MONTGOMERY COUNTY HISTORIC PRESERVATION COMMISSION
STAFF REPORT

Address:	10417 Armory Avenue, Kensington	Meeting Date:	8/16/2023
Resource:	Secondary Resource Kensington Historic District	Report Date:	8/9/2023
Applicant:	Frankly Pizza (Frank Linn, Agent)	Public Notice:	8/2/2023
Review:	HAWP	Tax Credit:	No
Permit Number:	1038875	Staff:	John Liebertz
PROPOSAL:	Construction of awning and lattice.

EXISTING PATIO ALTERATION

10417 ARMORY AVE, KENSINGTON, MARYLAND 20895

2 PROPOSED - RIGHT ELEVATION
A-2.0 SCALE: 1/4" = 1'-0"

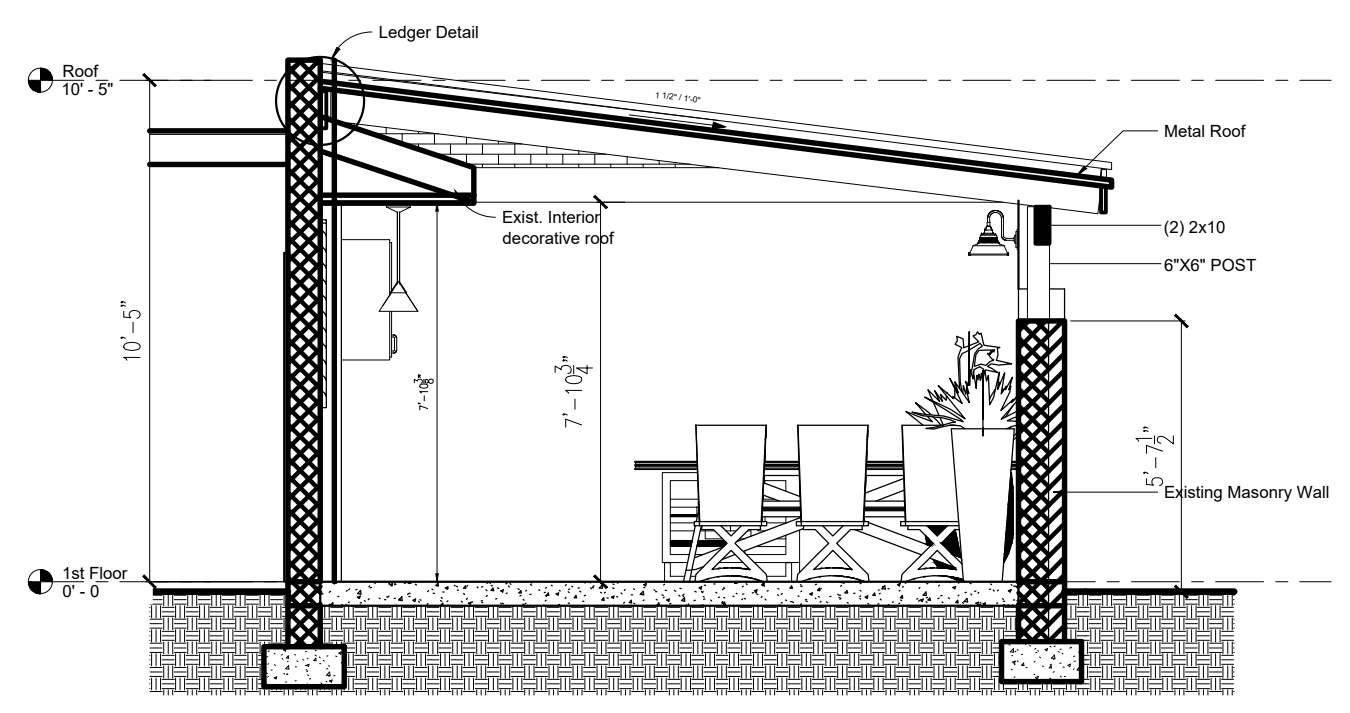
5. The applicant shall clarify whether there are skylights or vents in the corrugated roof since “Sheet A-2.0 – Proposed Right Elevation” depicts unlabeled openings and submit specification sheets if applicable.
